# Orchard Hills Section A Site Audit Report and Statement

Sydney Metro Western Sydney Airport Station Boxes and Tunnelling Works

<b>Project number</b>	WSA-200-SBT
<b>Document number</b>	SMWSASBT-CPG-OHE-SN150-EN-RPT-295264
<b>Revision date</b>	22/12/2023
<b>Revision</b>	1

# **SITE AUDIT REPORT**

Figure 9.1: Locations of Historical Offsite Groundwater Monitoring Wells (Source: the SAQP)

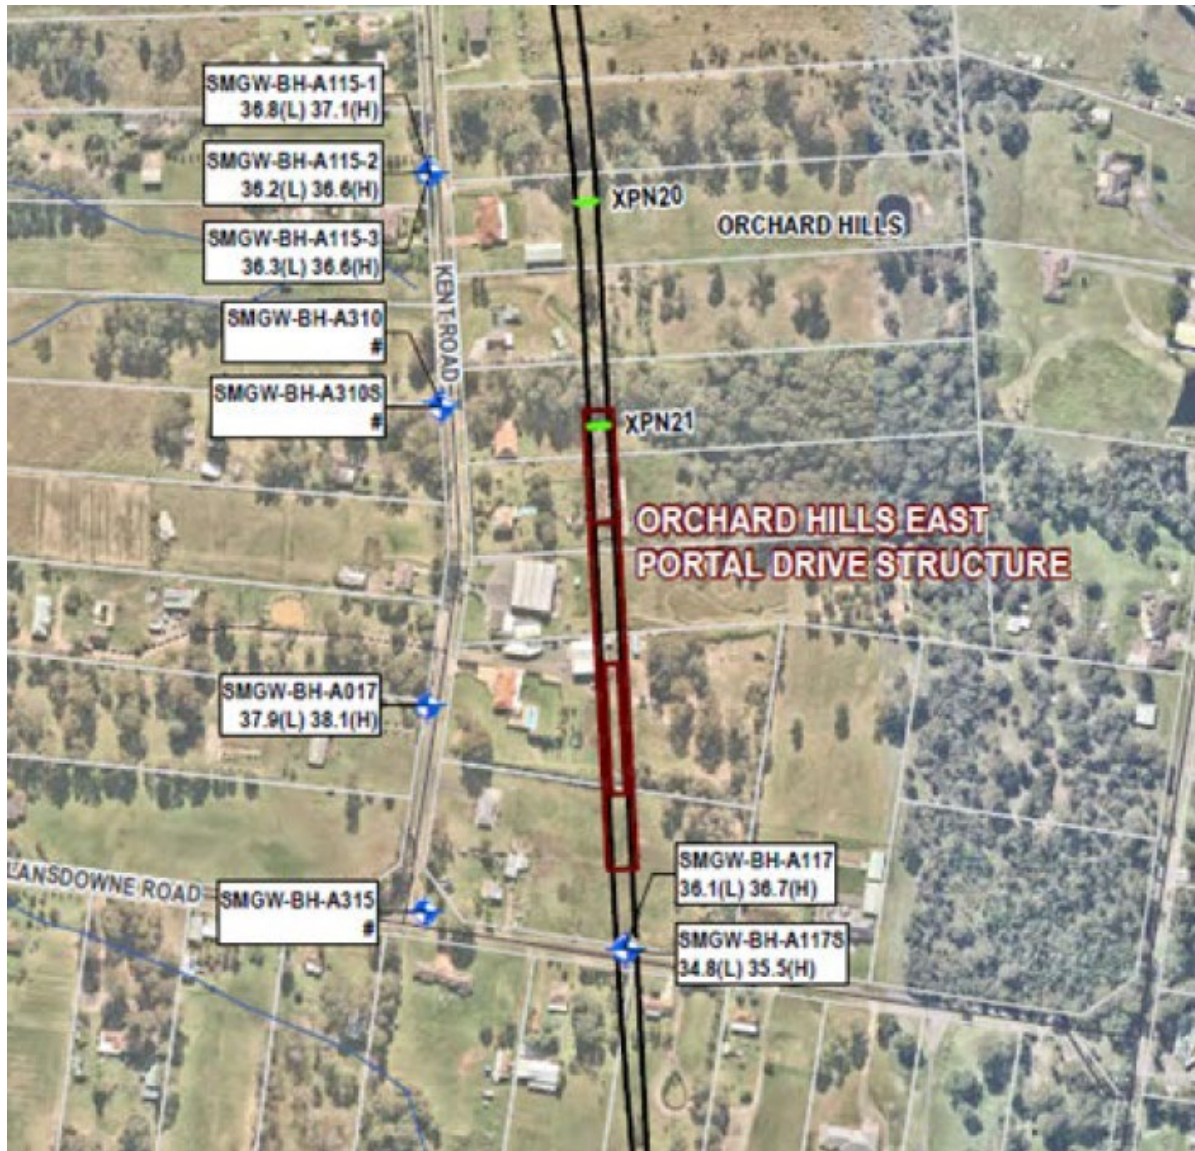
- Historically, groundwater wells including SMGW-BH-A017, SMGW-BH-A113, SMGW-BH-A117, SMGW-BH-A117S, SMGW-BH-A310, SMGW-BH-A315 and SMGW-BH-A315S were installed in immediate surrounds (**Figure 9.1**). These wells were sampled at least once in 2019, 2020 and/or 2021. Most of these wells were located to the immediate west of the OHS site in assumed up hydraulic gradient locations and reported similar analytical results to the DSI/DSI Addendum, indicating the reported metal, ammonia and nitrate concentrations in site groundwater could be representative of background conditions.

- The laboratory detection limit adopted for PFOS was greater than the HEPA (2020) criterion for 99% (0.00023  $\mu\text{g/L}$ ) but below the criterion for 95% (0.13  $\mu\text{g/L}$ ) freshwater species protection. Historically, PFOS concentrations exceeding the HEPA (2020) criterion for 99% freshwater species protection (and below 95% freshwater species protection) were reported in the assumed upgradient offsite monitoring wells SMGW-BH-A310, SMGW-BH-A315 and SMGW-BH-A315S (**Figure 9.1**), indicating that it is likely that the site groundwater contains PFAS.

- In consideration of the monitoring results, the PFAS concentrations in site groundwater are anticipated to be low (above 99% but below 95% species protection criteria). Given the nearest surface water receptors (Blaxland Creek and South Creek) are not of high ecological conservation value, adopting the HEPA (2020) criterion for 99% freshwater species protection to assess PFAS concentrations in groundwater is likely to be conservative and the overall risk associated with PFAS in groundwater is expected to be low.

The Auditor is satisfied that further investigation or remediation of groundwater is not required. Groundwater encountered during construction (if any) will require capture, treatment and disposal in accordance with the Water Reuse and Discharge Management Procedure provided in Appendix C of the NSW (Off-Airport) Soil and Water Management Sub-Plan.

Figure 1: Locations of historical groundwater monitoring wells SMGW-BH-A310, SMGW-BH-A315/SMGW-BH-A315S (Source: the SAQP)

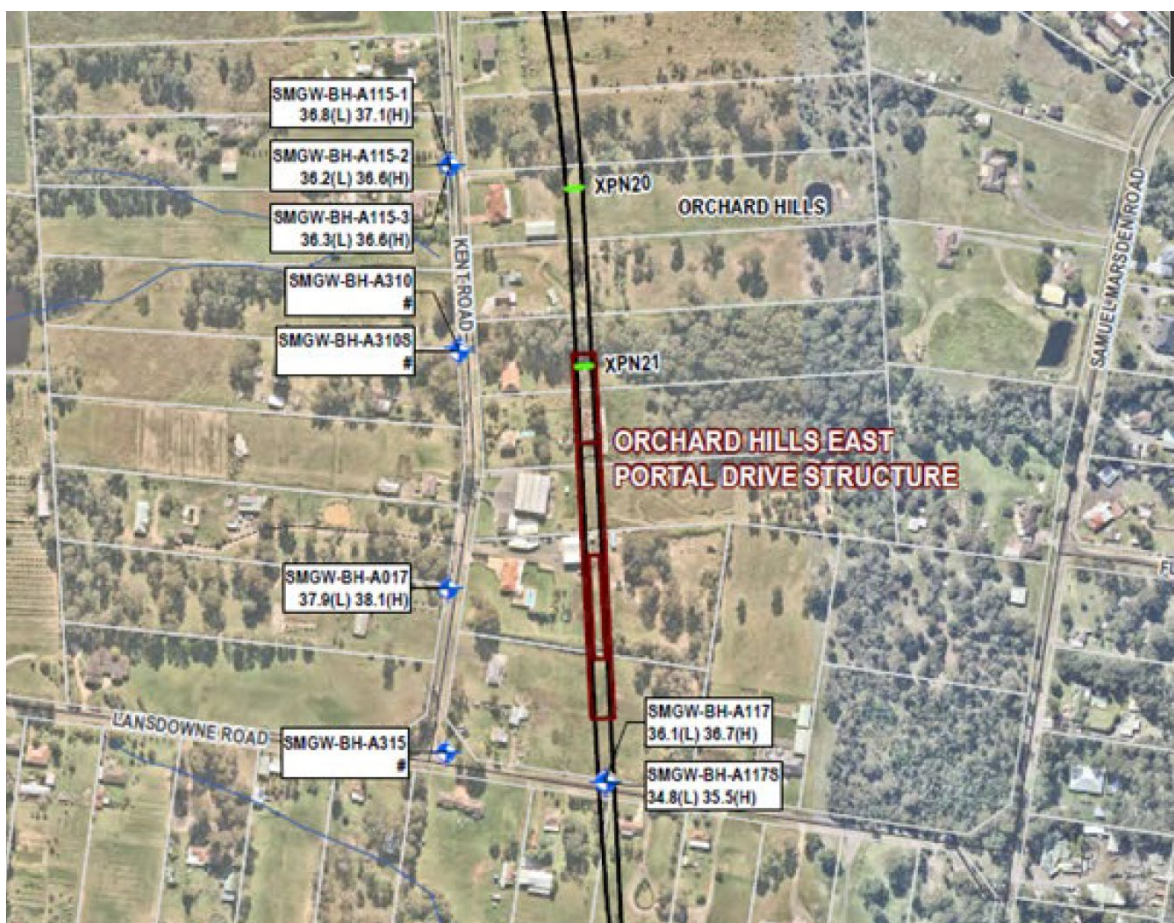
- The laboratory detection limit adopted for perfluorooctane sulfonate (PFOS) in the DSI/DSI Addendum was greater than the HEPA (2020) criterion for 99% (0.00023 µg/L) but below the criterion for 95% (0.13 µg/L) freshwater species protection. Historically, PFOS concentrations exceeding the HEPA (2020) criterion for 99% freshwater species protection (and below 95% freshwater species protection) were reported in monitoring wells SMGW-BH-A310, SMGW-BH-A315 and SMGW-BH-A315S. These wells were located to the immediate west of the site (Figure 1, assumed up hydraulic gradient), which indicates that it is likely that the site groundwater contains PFAS. In consideration of the DSI monitoring results, the PFAS concentrations (if present) in site groundwater are likely to be low (above 99% but below 95% species protection criteria).

- Given the nearest surface water receptors (Blaxland Creek and South Creek) are not of high ecological conservation value, adopting the HEPA (2020) criterion for 99% freshwater species protection to assess PFAS concentrations in groundwater is likely to be conservative.

In summary, it is the opinion of the Auditor that the findings from the DSI Addendum were consistent with the historical monitoring data and indicated groundwater is unlikely to pose unacceptable risk to the environment. The proposed six-monthly groundwater monitoring, including monitoring of the newly installed wells SBT-GW-1043 and SBT-GW-1063, during construction will allow ongoing assessment of such risks.
